Vermont Agency of Transportation
RECEIVED
 CK'D BY SC, TM OK'D BY G. Laroche
 March 18, 2016
 RESUBMIT No Approved
 BY K. Higgins DATE 3/28/2016

J.P. CARRARA & SONS INC. Precast & Prestress Manufacturer <small>2464 CASE STR., MIDDLEBURY, VERMONT 05753 Phone: (802)388-6361 Fax: (802)388-9010</small>		J.A. McDonald, Inc. CONTRACTOR LYNDON CENTER, VERMONT	
STATE OF VERMONT AGENCY OF TRANSPORTATION COUNTY OF RUTLAND		DATE: JAN. 8, 2016 SCALE: NOTED	
TOWN OF CLARENDON WALKER MOUNTAIN ROAD, TH #3, RURAL COLLECTOR BRIDGE NO.: 11 PROJECT NO.: BRO 1443(4B)		CHKD: B.C. DFTM: T.D. JOB NO: 23476-015	
PRECAST NEXT BEAM LAYOUT		DWG. NO: F2

1 PRESTRESSED NEXT BEAM & APPROACH SLAB LAYOUT
 1/4" = 1'-0"

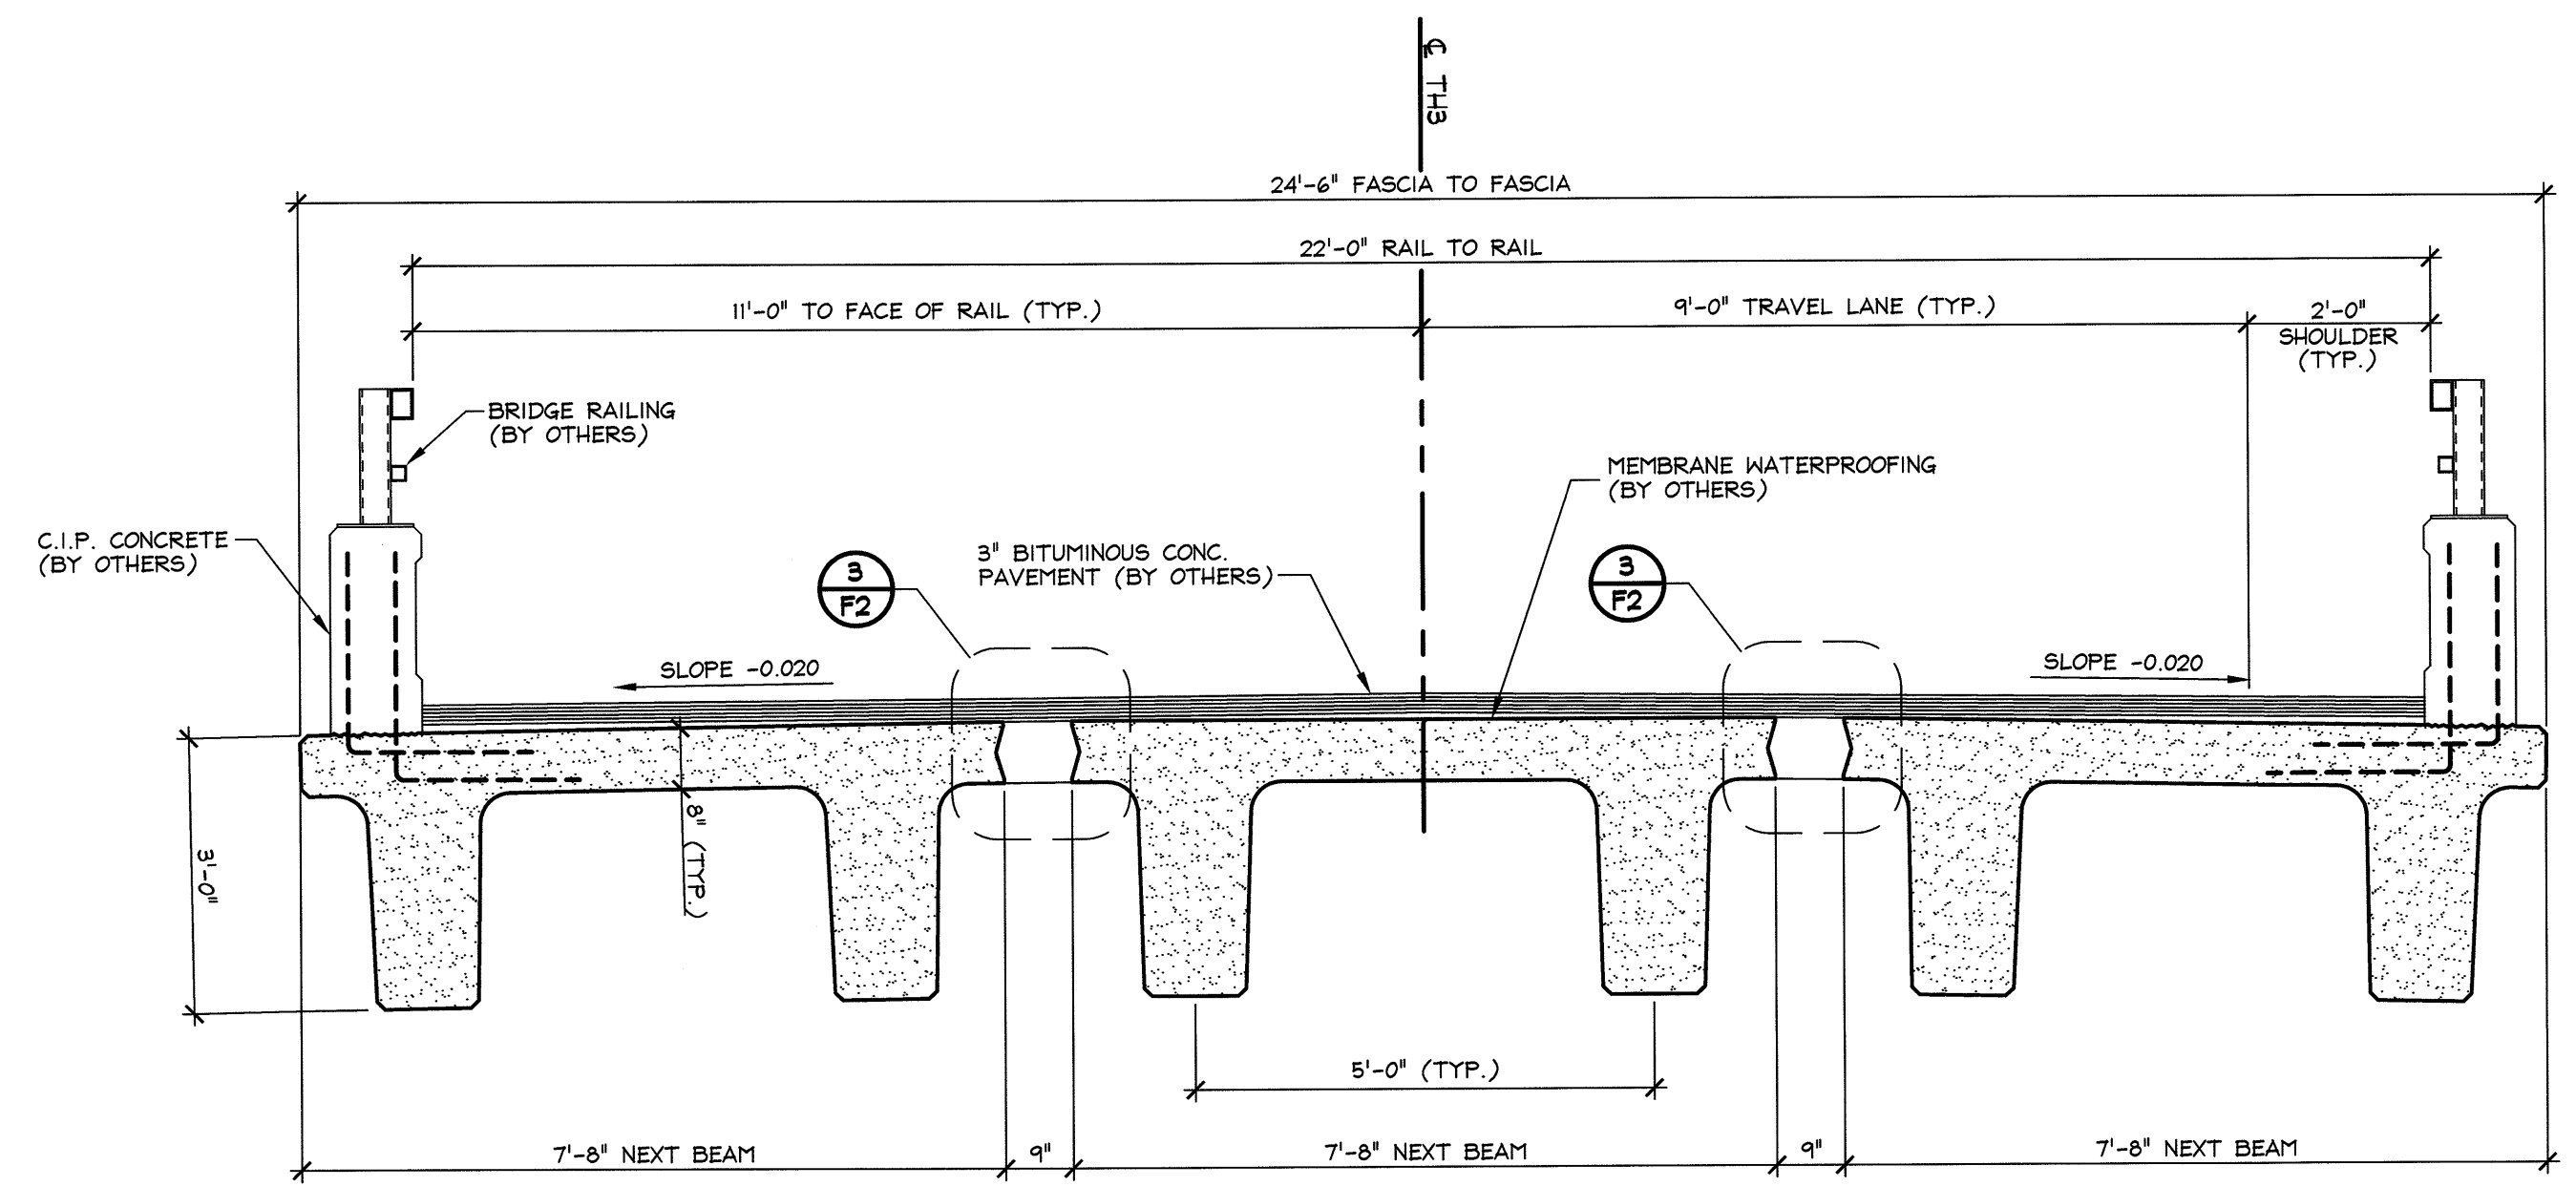
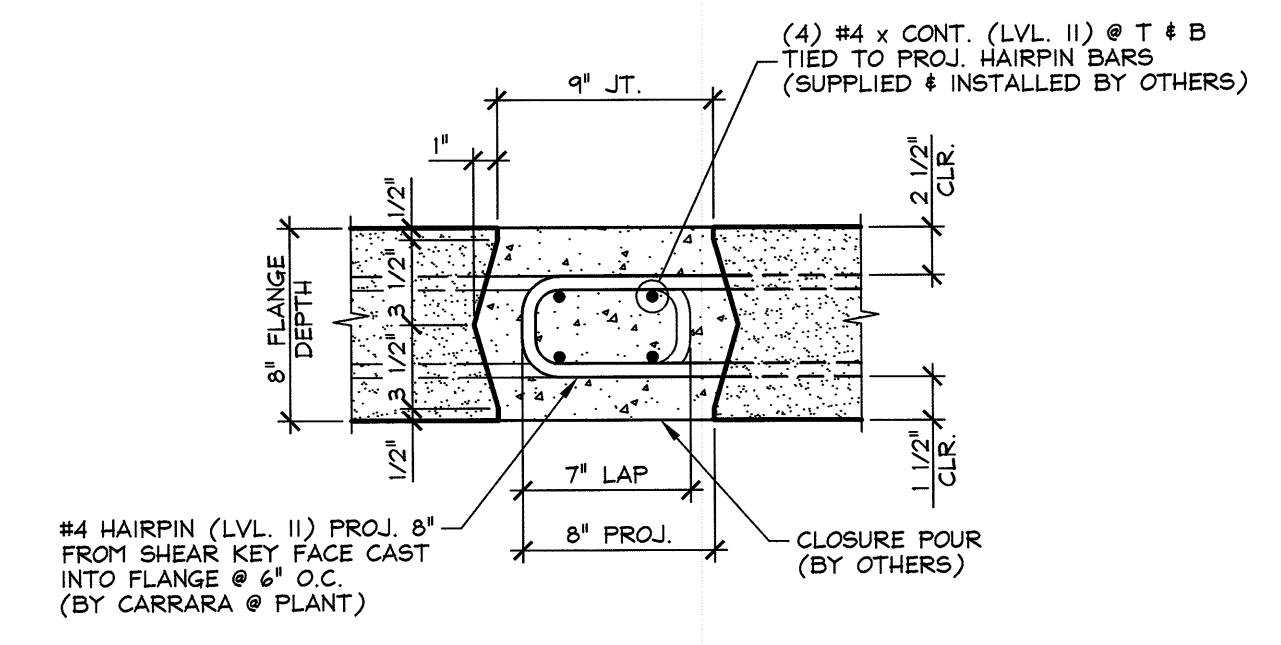
3/1/16 REVISED AS PER ENGINEERS COMM. T.D.
